TRANSPORTATION MEMORANDUM

TO: Sylviane Charette, Manager, University of Ottawa
FROM: Sarah McDonald, P. Eng., Project Manager, Transportation Planning, WSP
SUBJECT: uOttawa 200 Lees Site Plan Control Application - Supplement to draft Transportation Impact Assessment
DATE: June 28, 2021

This technical memorandum is intended to supplement Section 5.1.2 - Circulation and Access of the draft TIA Report. It provides a summary of the key transportation differences between the indicative site plan discussed in the draft TIA (September 28, 2020) and the modified site plan prepared for this Site Plan Control Application (June 28, 2021).

**Figure 1. Indicative Site Plan
September 2020**

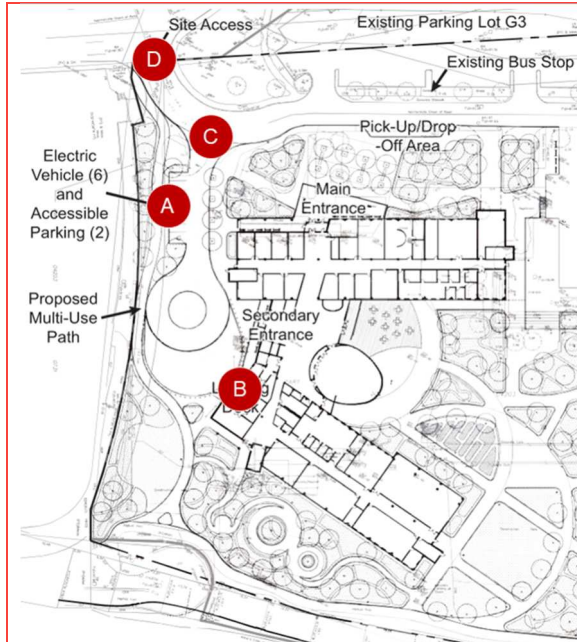
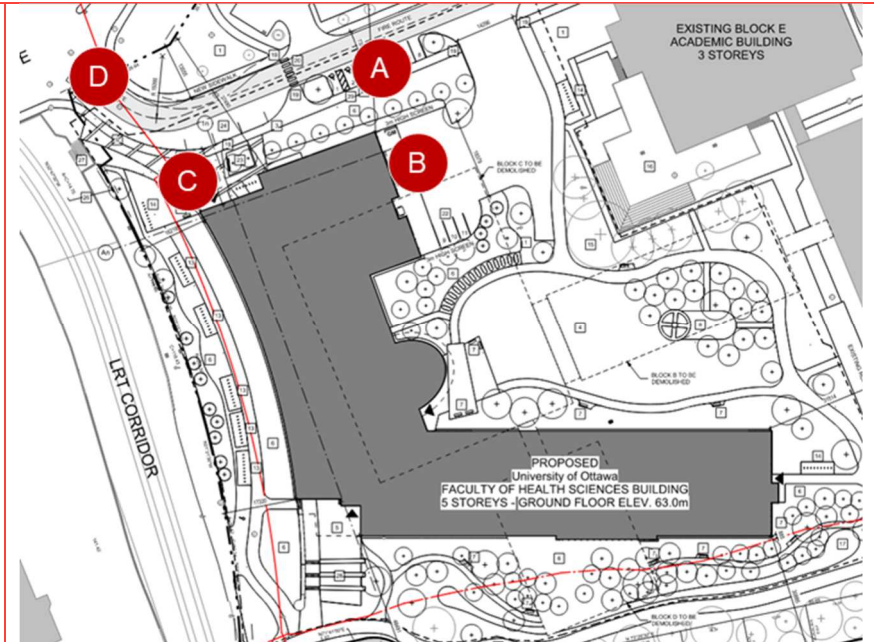
The site plan assessed for the draft Transportation Impact Assessment Report and the proposed site plan are shown side by side in **Figure 1** and **Figure 2**. Annotated on each are the four main transportation related changes to site plan which include:

- A. Parking relocation
- B. Loading dock relocation
- C. Pedestrian and cyclist circulation
- D. Geometric changes to the site access at Lees Avenue

SITE PLAN ELEMENT	INDICATIVE SITE PLAN	FINAL SITE PLAN	TRANSPORTATION IMPACT	
A. PARKING	Location	90° angle on-street parking provided in the loading dock accessway; east of building and along the west edge of the site.	90° angle on-street parking provided along the existing road; north and adjacent to the proposed new building.	The final site plan provides an increase in accessible parking spaces; a reduction in the potential for pedestrian / vehicle conflict providing parking adjacent to the building with direct sidewalk access; and continues to offer electric vehicle charging stations. The existing on-site traffic flow along the road may be disrupted as a result of vehicle parking maneuvers.
	Spaces	Two accessible spaces and six electric vehicle spaces	Four accessible spaces with access aisles provided. Four additional spaces with electric vehicle charging capabilities	
	Access	Vehicles accessing the proposed parking area cross the pedestrian route the along the south side of the road. Parking maneuvers separated from the road.	Vehicle movements separated from pedestrian movements. Parking maneuvers may disrupt on-site traffic flow along the road.

Walking Route to Building	Driver and passengers cross parking and delivery lane to access building entrances	Drivers and passengers have direct access via a sidewalk.

B. LOADING DOCK	Location	South of the proposed parking area along the west side of the proposed building. Depressed truck apron	East of the proposed building and visually obstructed by a 3m high screen.	Relocating the loading dock area to the east side of the proposed building reduces the number of potential total conflicts between trucks and pedestrians / cyclists circulating along the south side of the road. Separating the loading dock area from the potential pick-up and drop-off activities Trucks will continue to travel past the proposed on-street parking; however, in the final site plan, trucks will be mixed with existing site traffic.
	Docks	Not defined in the draft TIA.	Two loading docks with an additional three parking spaces available.	
	Access	Heavy vehicles access the loading dock from the main road and in advance of the main building entrance. Truck maneuvering was accommodated through a depressed truck apron in a shared space meant for loading / delivery actives and as an alternate pick-up drop off area.	Heavy vehicles access the loading docks from the main road between the proposed building and the existing Block E academic building. Truck maneuvering is accommodated through a large paved area that is separated from other uses.

SITE PLAN ELEMENT	INDICATIVE SITE PLAN	FINAL SITE PLAN	TRANSPORTATION IMPACT	
C. PEDESTRIANS	Pedestrians	<p>As existing.</p> <p>Pedestrians accessing the site from Leeds Avenue circulate towards the main entrance on either side of the internal road.</p> <p>In advance of the main building entrance, the south sidewalk crosses the vehicle access to the proposed parking and loading areas. It is assumed that there would be no change to the existing north-south pedestrian crossings at the existing G3 parking area.</p>	<p>Pedestrians accessing the site from Lees Avenue can circulate towards the main entrance along the south side of road without interacting with motorized vehicles.</p> <p>Pedestrians on the north side of the road will continue to have a dedicated crossing at the termination of the existing sidewalk located west of the existing G3 parking area.</p>	<p>The final site plan reduces the potential total conflicts between vehicles and pedestrians / cyclists by providing direct access to the main building entrance from Lees Avenue.</p> <p>The location of the open and sheltered bicycle racks near both the main and secondary entrance promotes the active mode.</p>

Cyclists	<p>As existing.</p>	<p>Cyclists accessing the site from Lees Avenue can circulate towards the proposed bicycle parking along the south side of road without interacting with motorized vehicles.</p> <p>A large bicycle parking area with both open and sheltered racks is provided in the area west of the proposed building.</p>

D. SITE ACCESS	Geometric Improvements	No geometric improvements proposed.	No geometric improvements proposed.	N/A

This review of the key differences to the proposed vehicle, pedestrian, and cyclist movements would not substantially change the commentary provided in the Circulation and Access section of the draft Transportation Impact Assessment (by others). However, should the City of Ottawa request additional transportation assessment in this respect, it is expected that they would be addressed through the finalized Transportation Impact Assessment to be completed by IBI Group.
